**Glacier Software**

**V1.2**

**January 2020**

# Studer Glacier Software Version 1.2

### New Function Block for Gain/Cal+

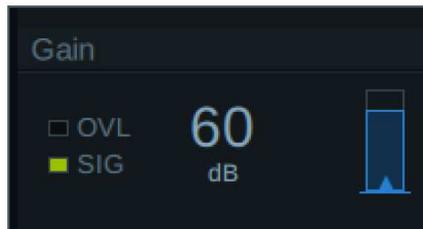
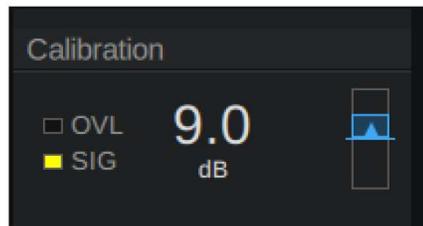
The new Gain/Cal+ Function Block can be assigned to any Global View Layout at any desired position within the channel.

Depending on the channel type, the Function Block provides direct access to either the analogue microphone input gain or the digital calibration level of a line input.

In either case, overload- and signal indicator inform the operator about the signal state.

The current value is indicated numerically and graphically.

Microphone input gain is indicated and can be controlled for inputs of type Mic.

Calibration Level is indicated and can be controlled for inputs of type Line.

Note: SIG (input signal > -40dBFS) is only indicated while the channel meter mode is set to pre fader.

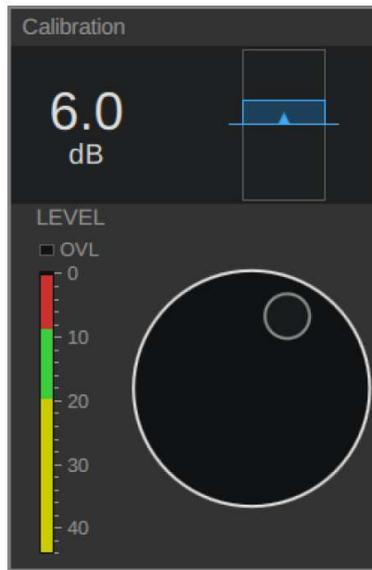
Touching the Function Block opens the software encoder to adjust the value:

The software encoder indicates prefader level on the input meter.

Note: Input level is only indicated while the channel meter mode is set to pre fader.

## New Function Block/Local View Page for AUX1..4 Contribution

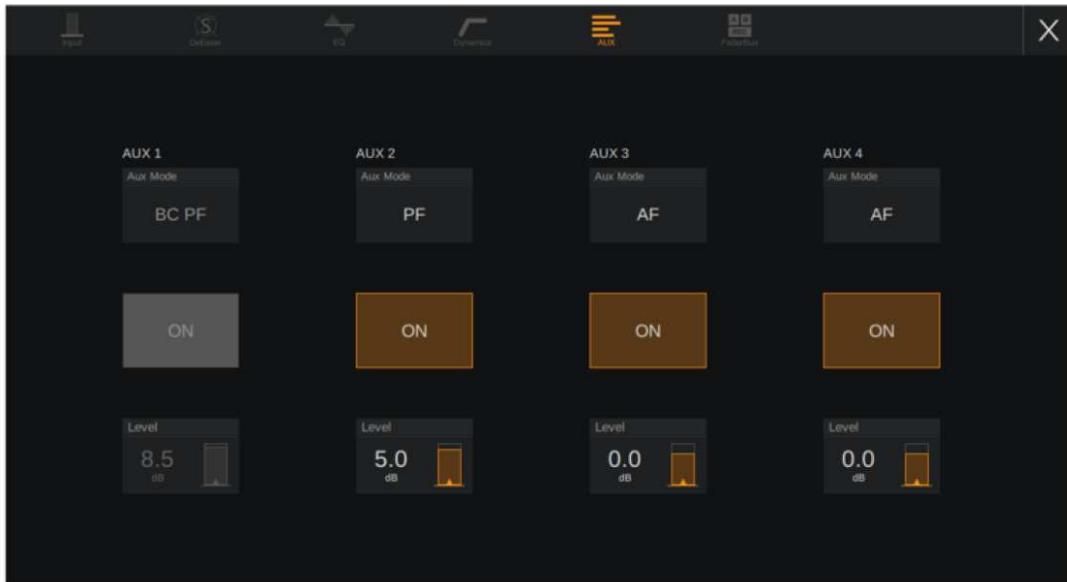
The new Local View page provides access to AUX1..4 contribution of each input channels.

It can be used to setup AUX contribution per channel instead of using the AUX Mix View, which cannot be accessed, as long as no AUX summing busses are assigned to strip channels.

The AUX Local View page allows control of AUX Mode, Contribution On/Off and Contribution Level.

Greyed out controls indicate to the operator, that the selected state is currently overwritten by system logic.

The above screenshot shows that pre-fader contribution to AUX 1 is currently suppressed, since the channel is on-air and Broadcast PF is the selected Aux Mode.
